**Hydrology Study Submittal Checklist and Application**

Hydrology Study Title SNWA River Mountain Solar Date 04-21-2015

Southern Nevada Water  
Authority River Mountains  
Solar

Subject: Technical Drainage Study Review Comment Responses

SHEET NO.:  
**FIG. 4**

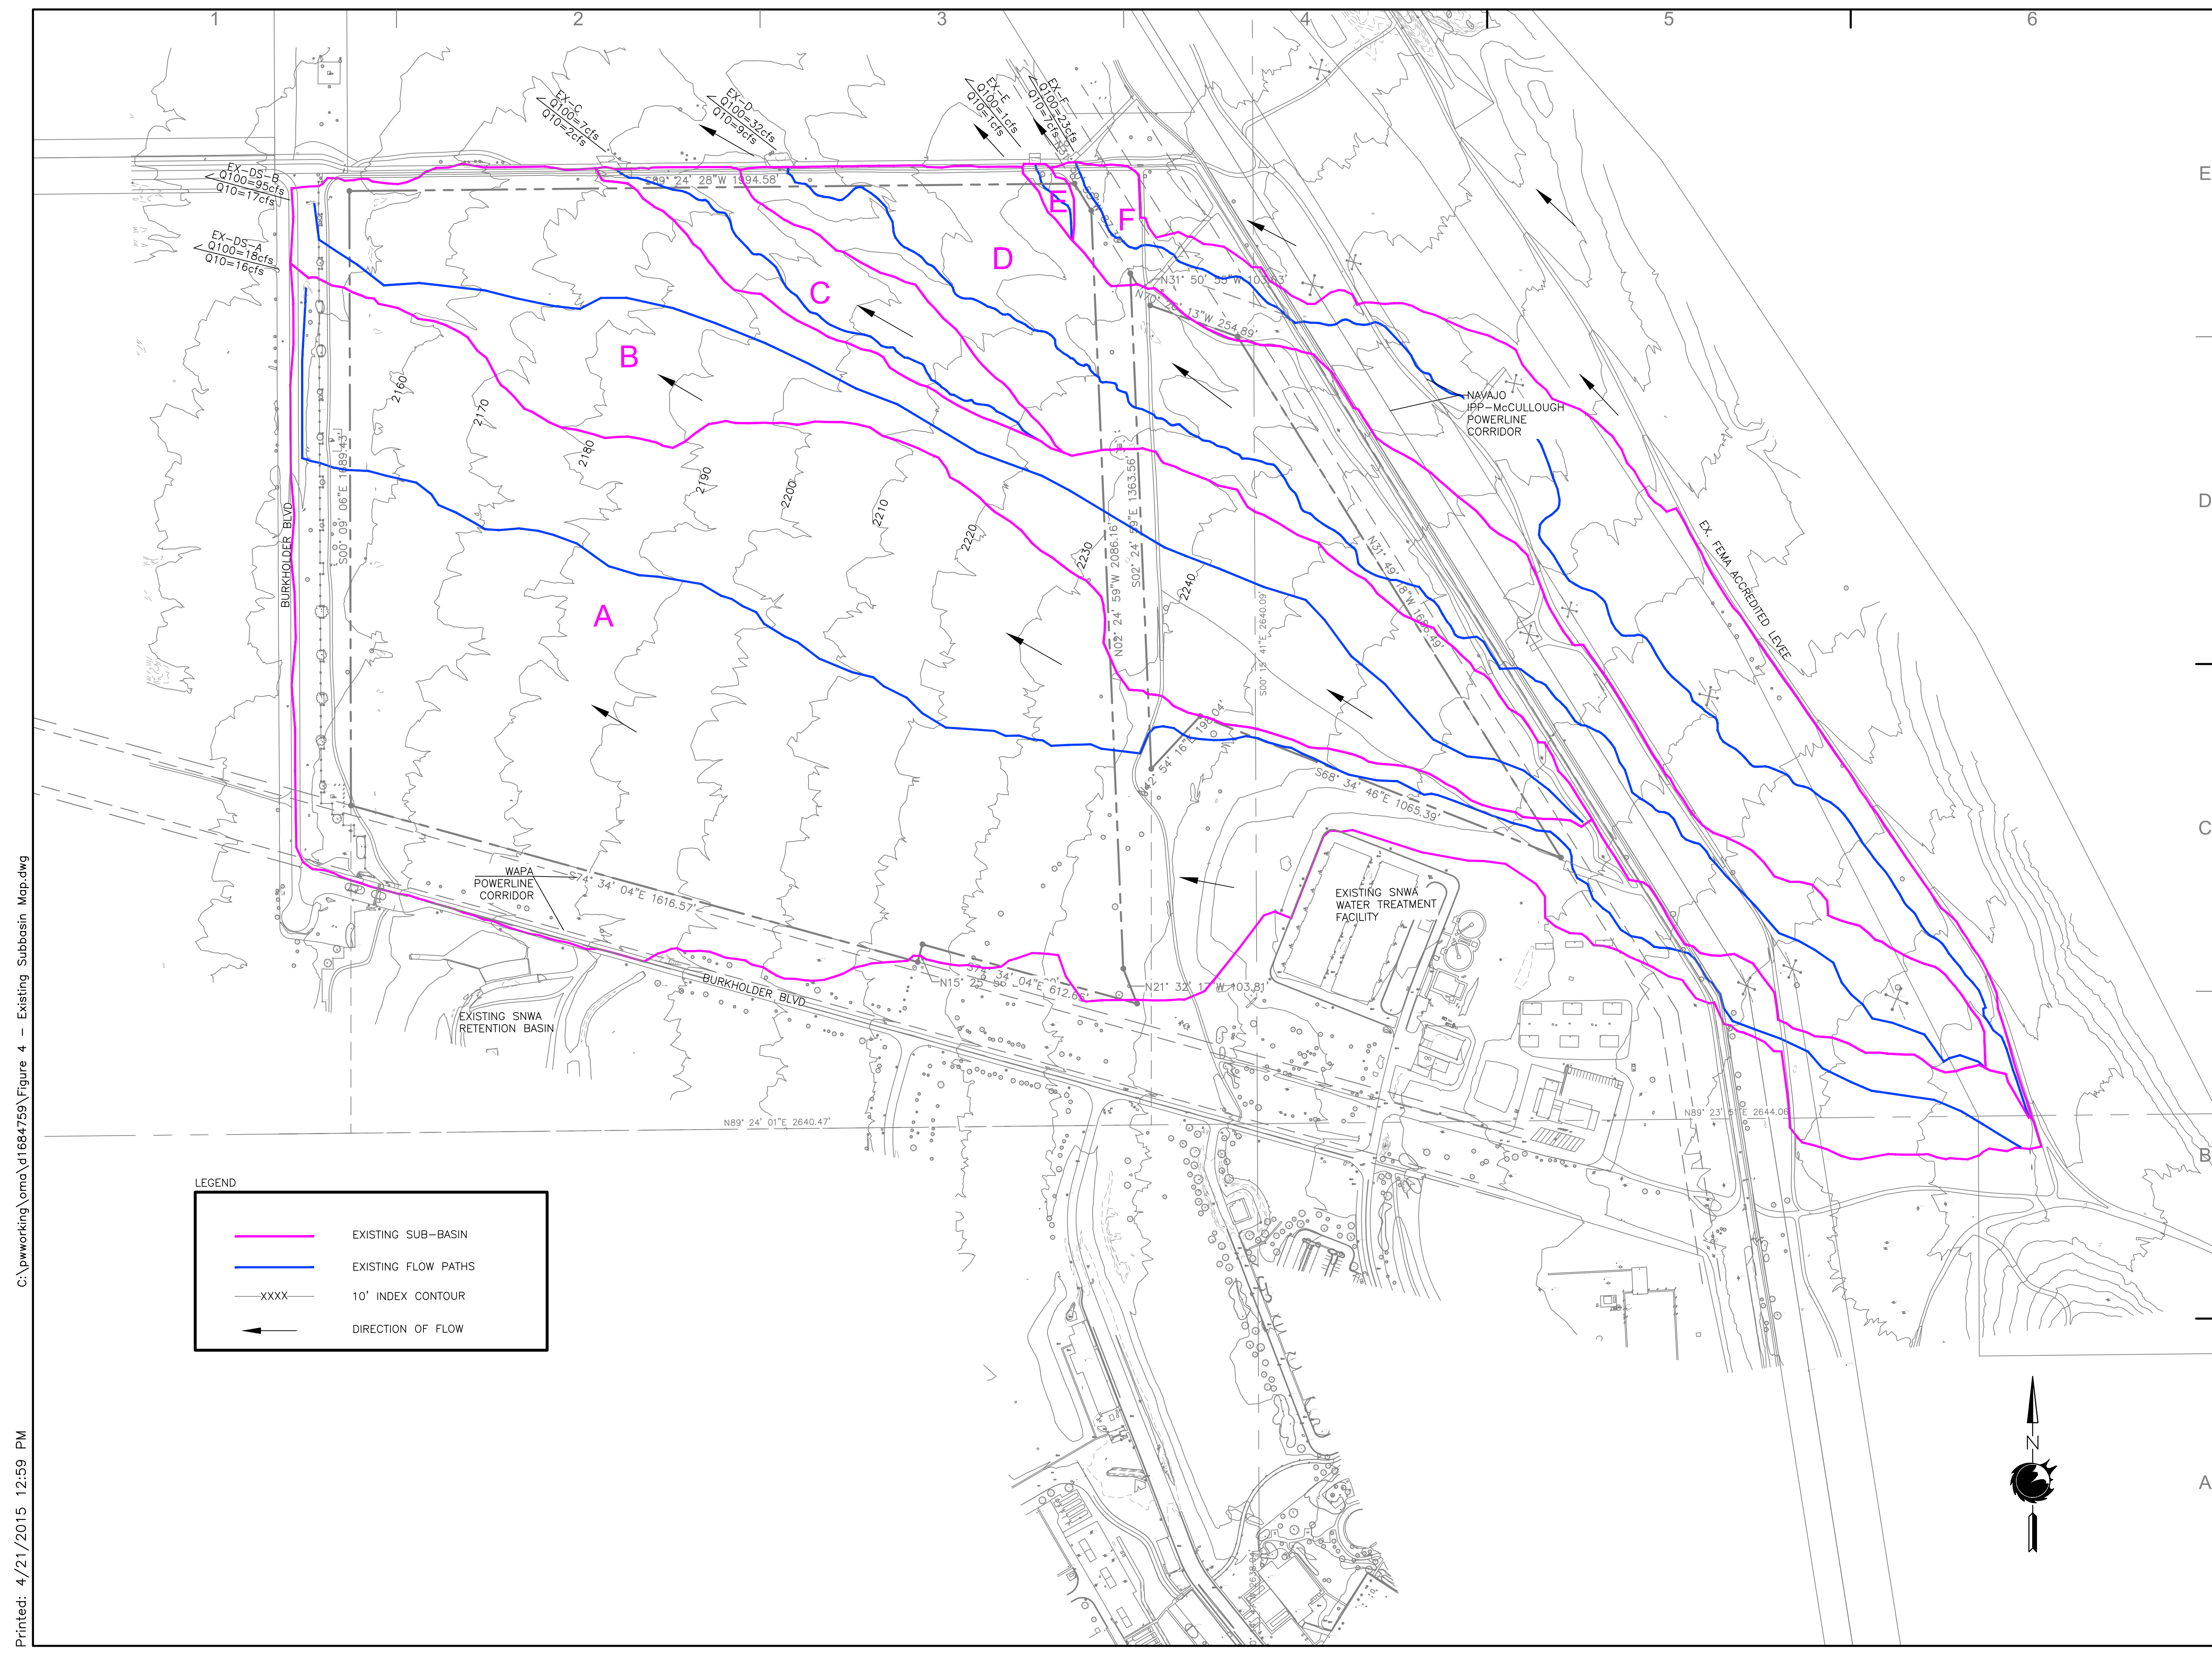
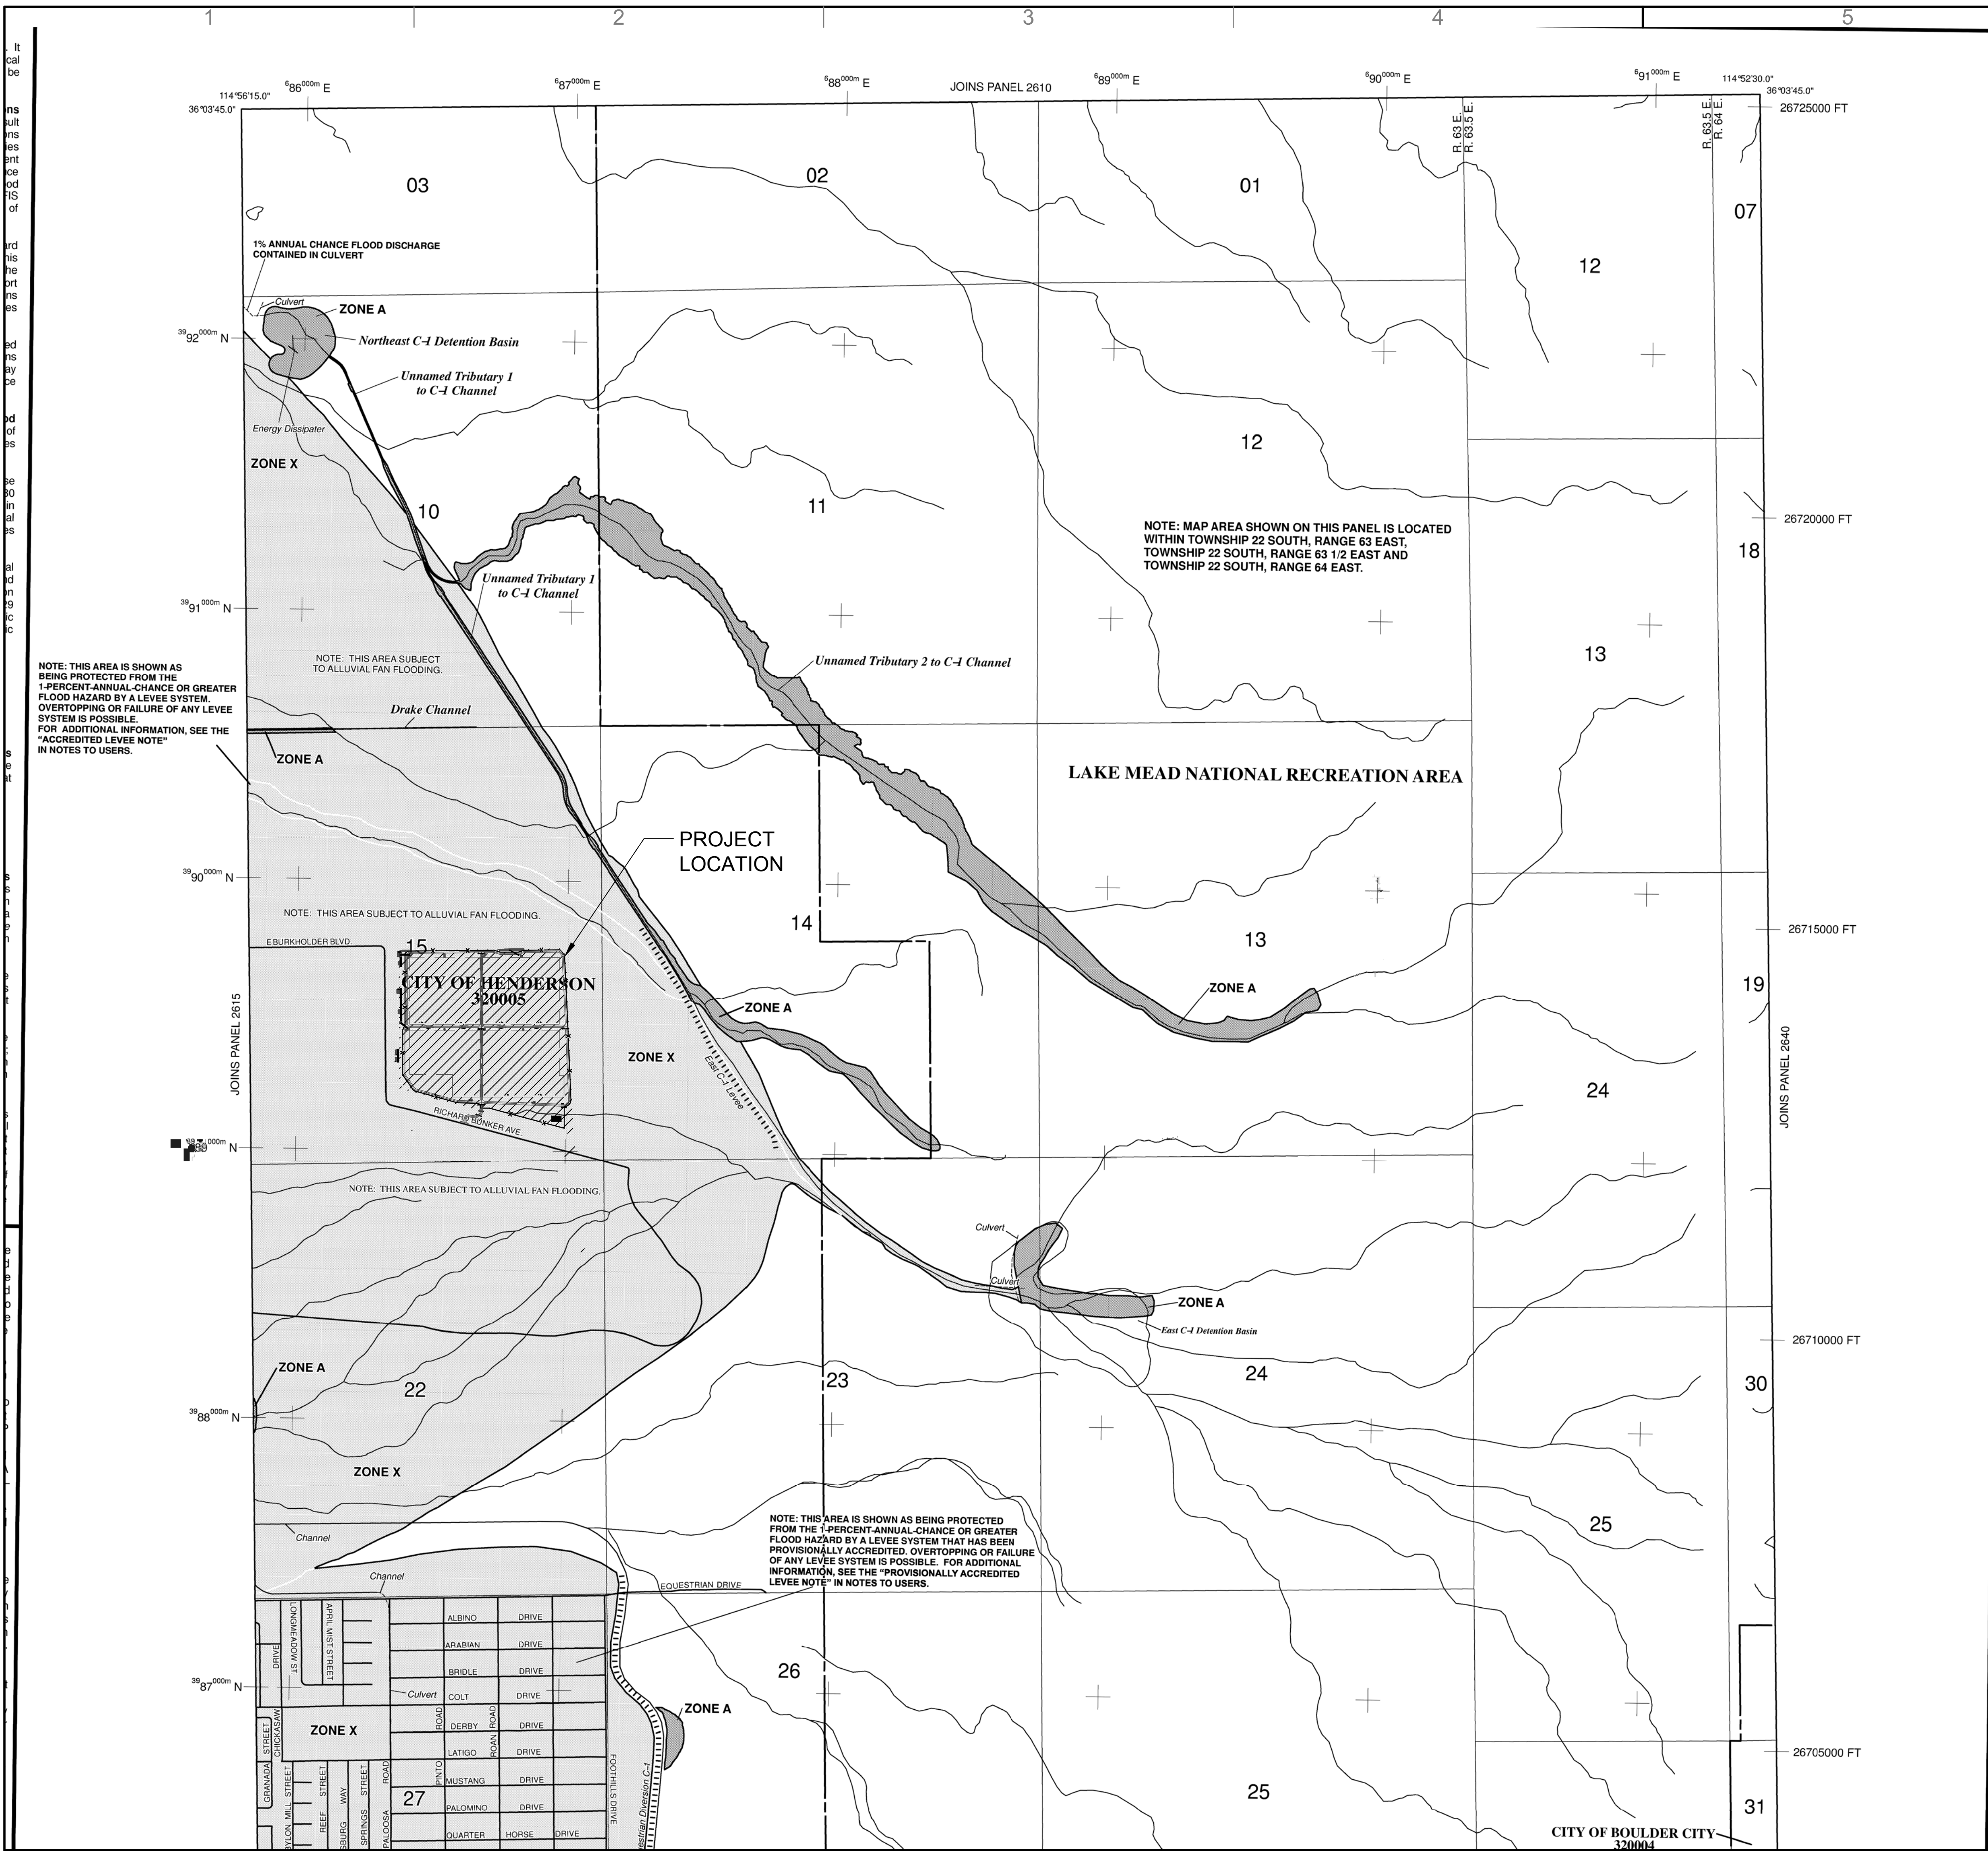
7. Figure 4, Existing Subbasin Map, must be revised to remove the proposed improvements from the map.

*Figure 4 was revised to remove proposed improvements.*
